Commercial/Multi-Family Design Review Committee

Friday, October 31, 2025

1. [24-0583](#) Review of plans for the commercial development located at 3800 State Rd 16.
(7 Brew Coffee)

SUBJECT: COMMERCIAL DESIGN REVIEW PROJECT
7 BREW COFFEE- VALLEY VIEW MALL

A2.3

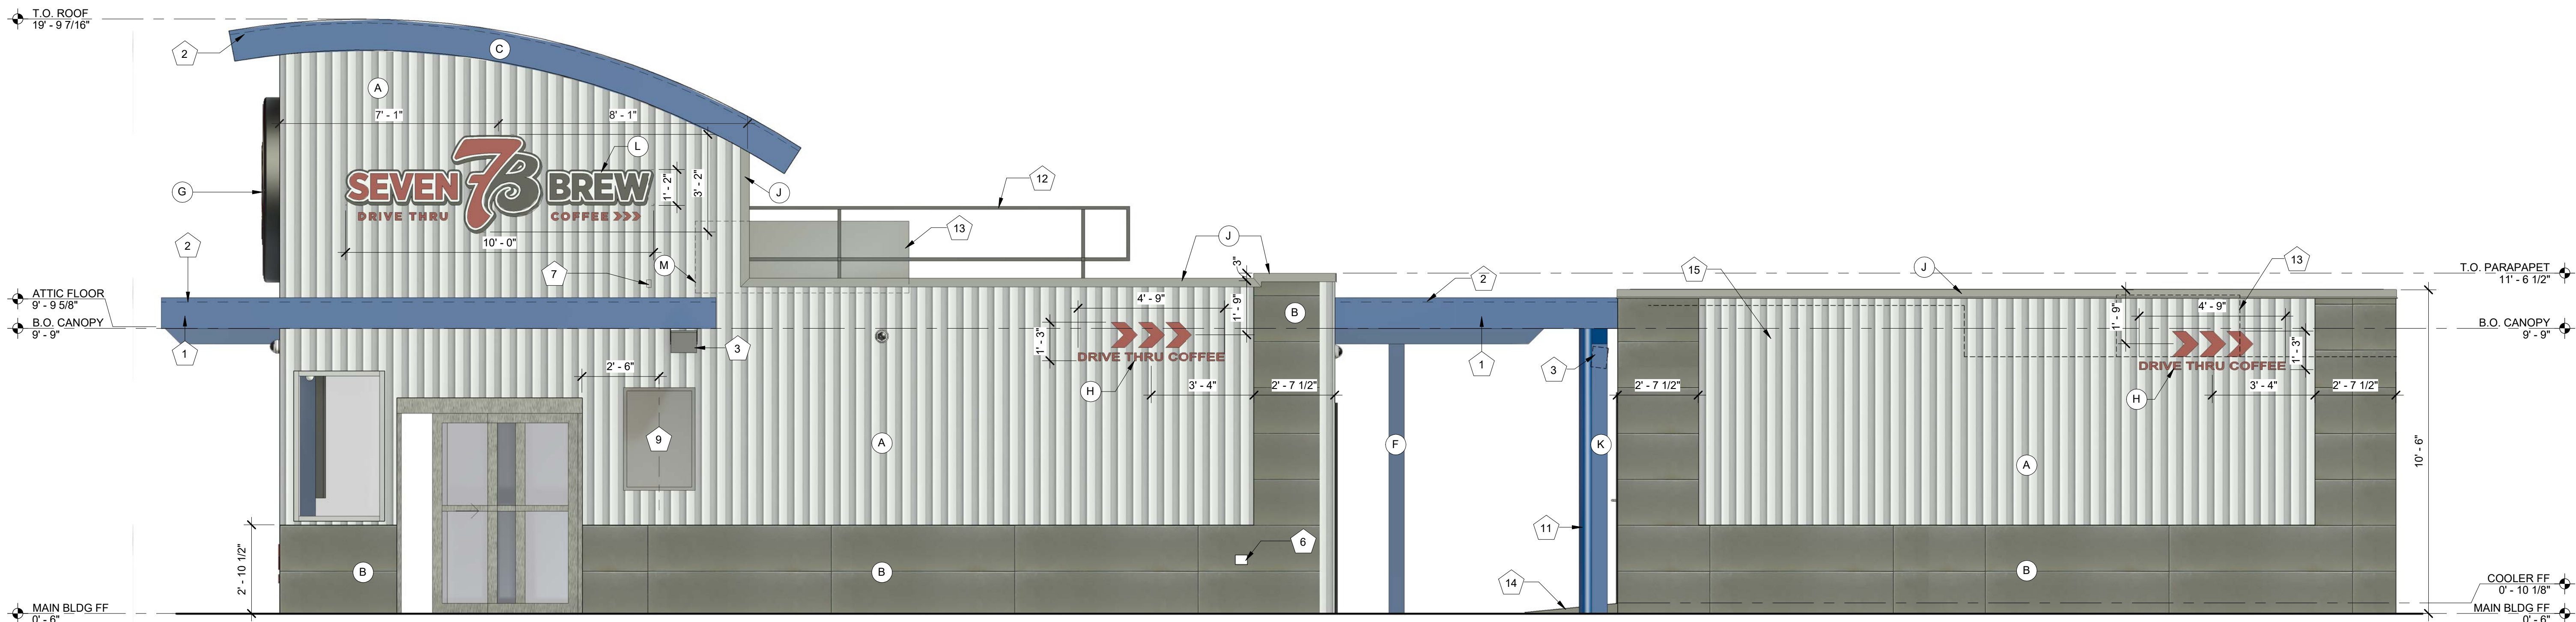
- 5) K5- Visual connection of building facing Hwy 16. 20% of northwest elevation must be windows and doors. Please provide calculation.
- 6) Section F. Must provide a Landscaping Plan as part of the final plan review.
